Note:
Deleted under Contract Change Order No. 9 - Install a new 30-inch drainage system.

DRAINAGE DETAILS

KAUMUALII HIGHWAY
Huleia Bridge Replacement & Approaches
F.A. Proj. No. BR-F-50-1(7)

PLAN
STA. 267+75

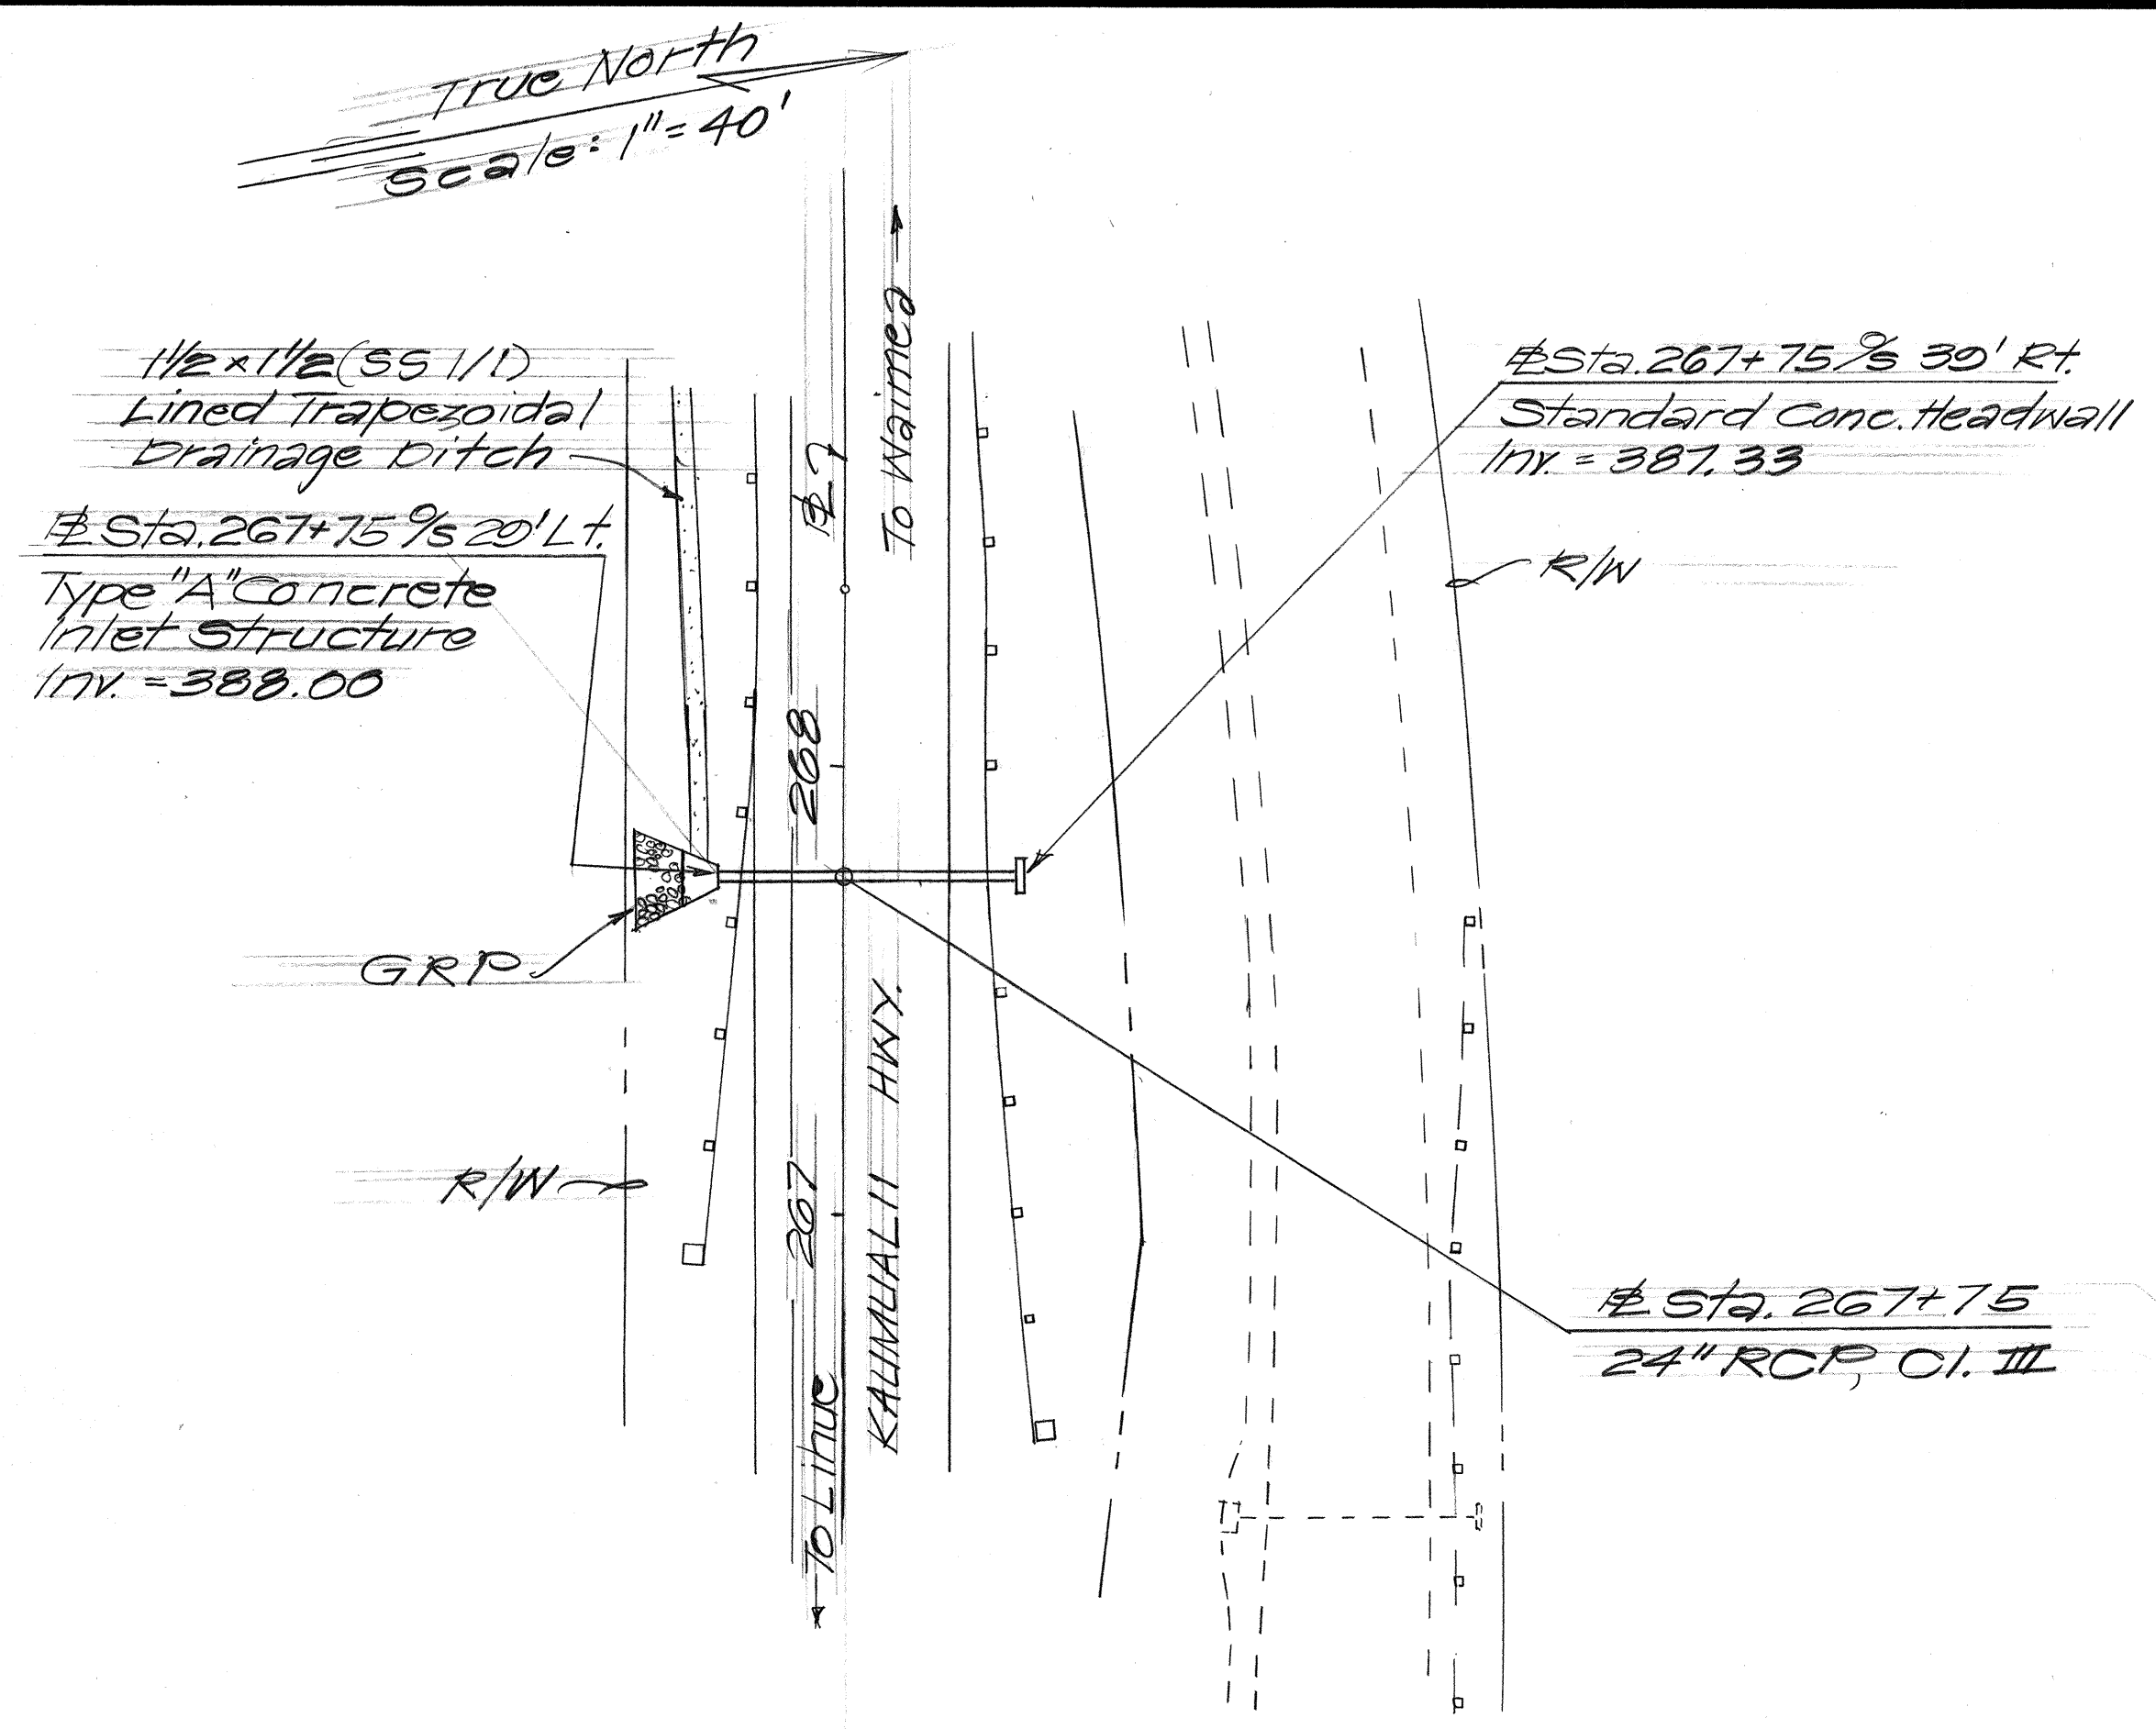
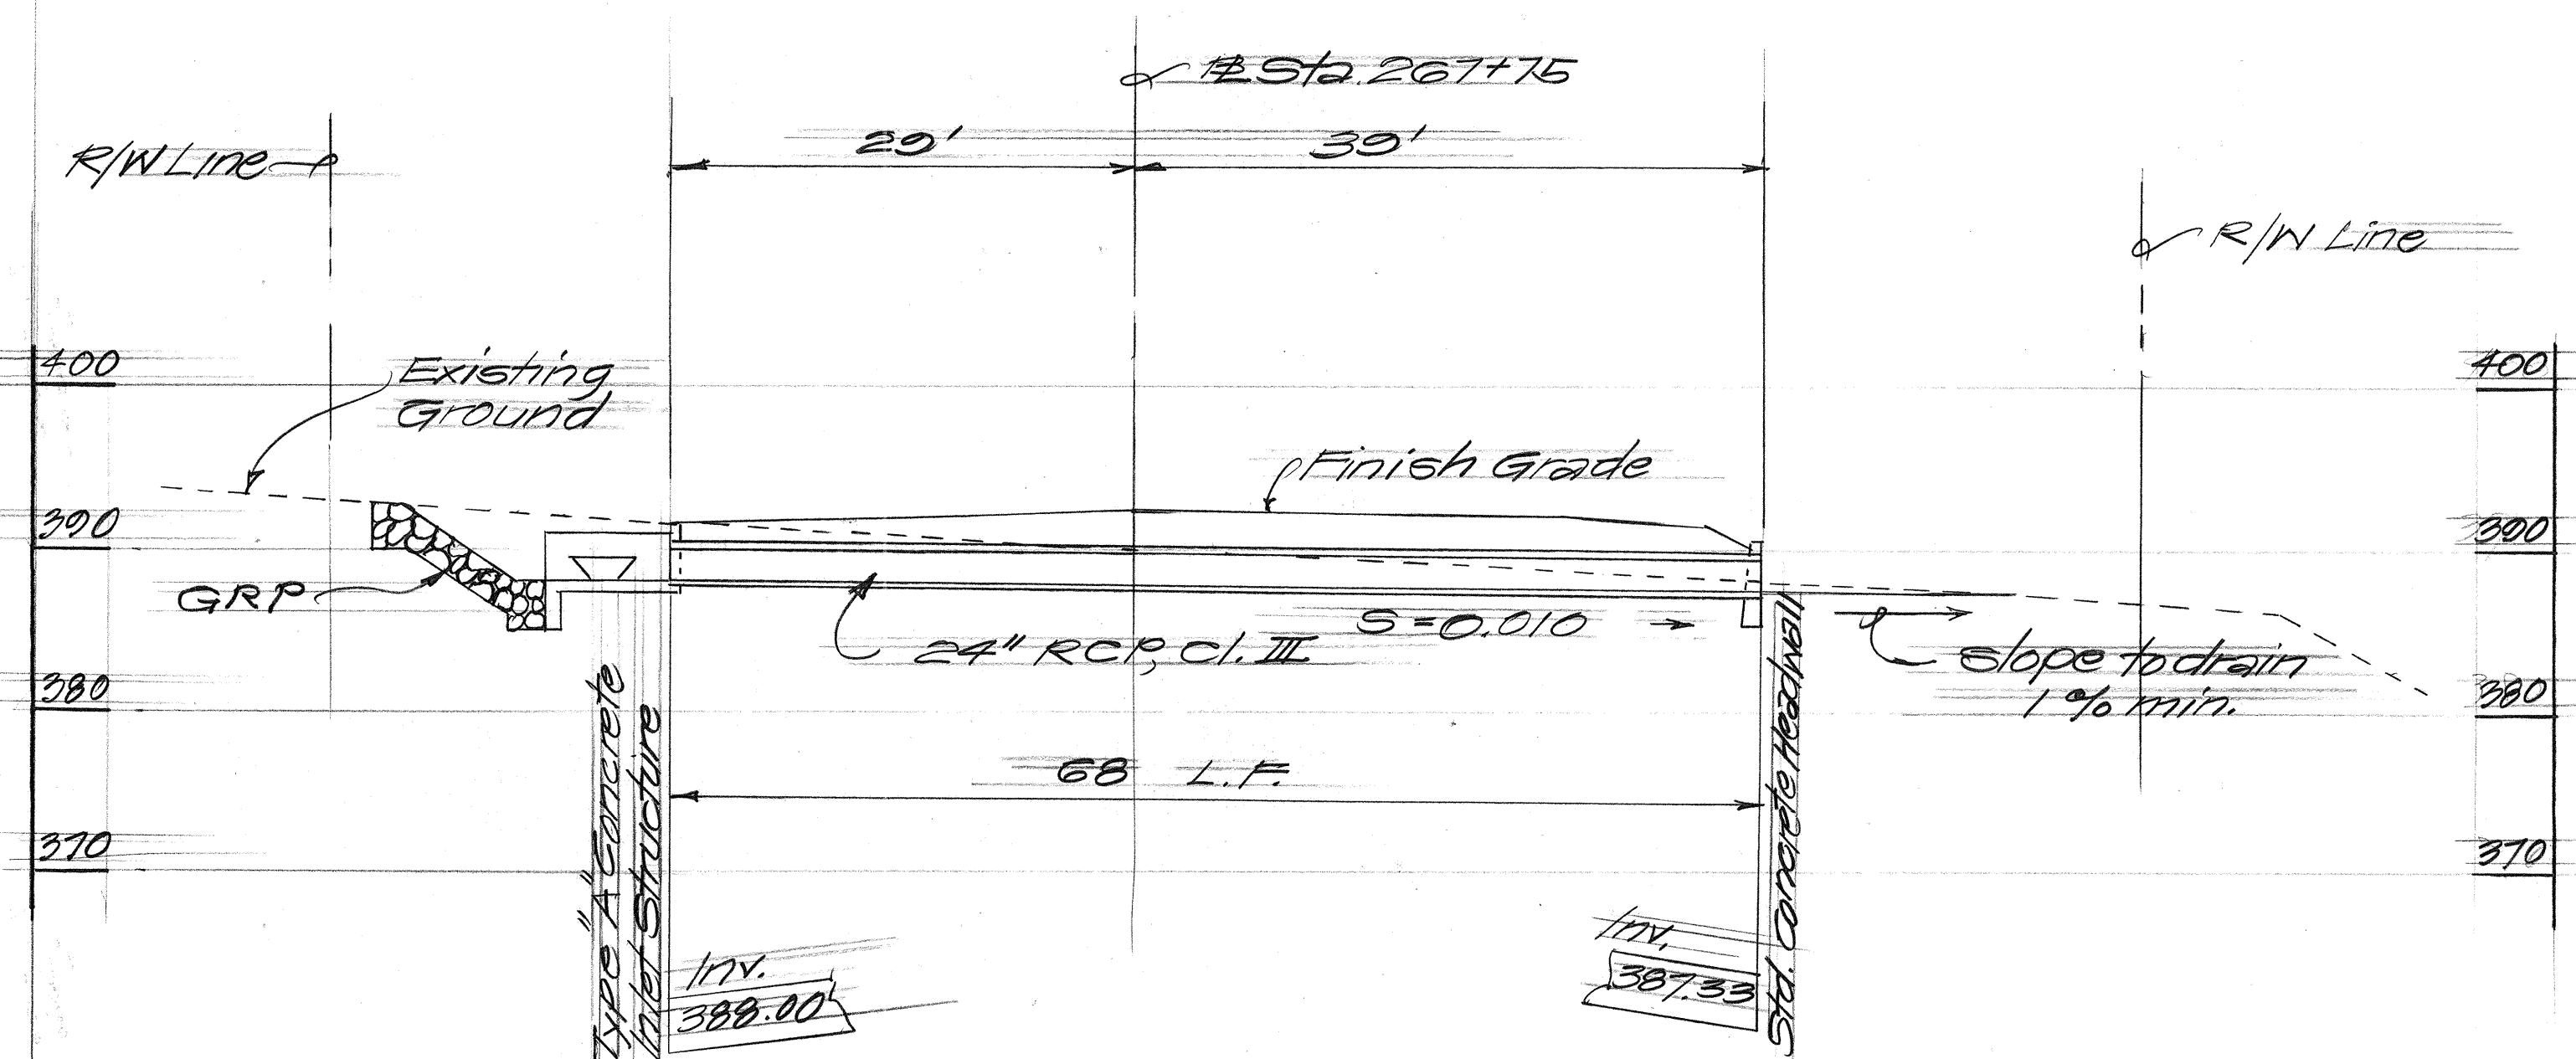
ESTIMATED QUANTITIES
Structural Excavation 19.60 ~~74~~ C.Y.
Class A Concrete 0.67 ~~7~~ C.Y.
Reinforcing Steel 538 ~~350~~ Lbs.
Bed Course Material
For Culverts 10.90 ~~12~~ C.Y.
24" RCP Cl. III 10.10 ~~68~~ L.F.
Grouted Rubble Paving 20.80 ~~74~~ C.Y.
